Amendments to the Drawings

Serial No. 10/020,951 Amendment dated January 13, 2004 Replacement Sheet

FIG. 23A

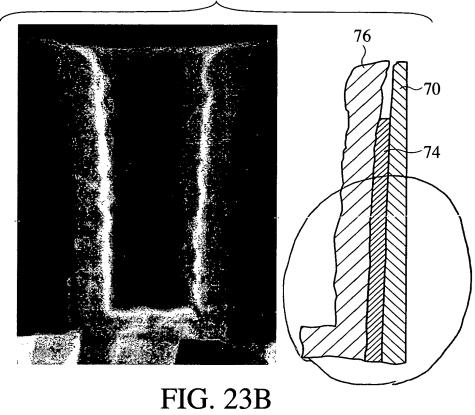
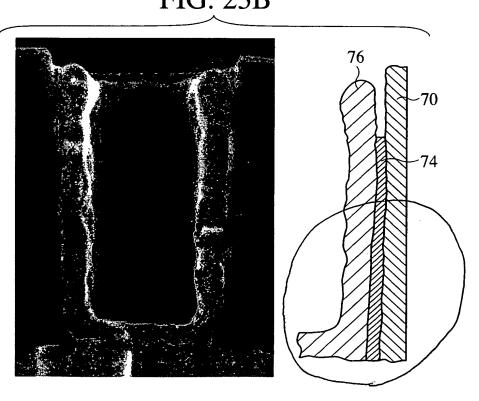
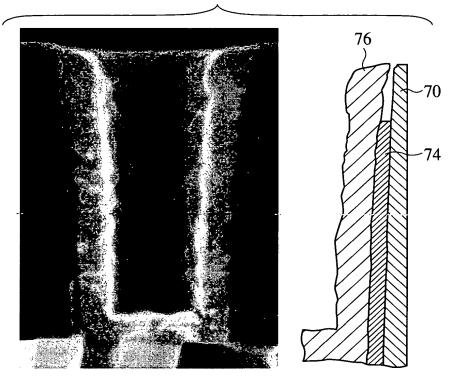
FIGS. 23A and 23B have been amended as shown in the attached "Replacement Sheet" and "Annotated Sheet Showing Changes."

These drawings have been amended to clarify the border portion between the bottom and side surface of the storage electrode. The amendments are based on the SEM image of FIGS.

23A and 23B, and these amendments do not introduce new matter.

As described in lines 1-5 of page 39 of the present specification, the edge of the storage electrode shown in FIG. 23A is rounded and thickened in a substantially spherical and thickened configuration as shown in FIG. 23B. Also described in the specification and shown by the original SEM images of FIGS. 23A and 23B, the border between the bottom and the side surface is also rounded.
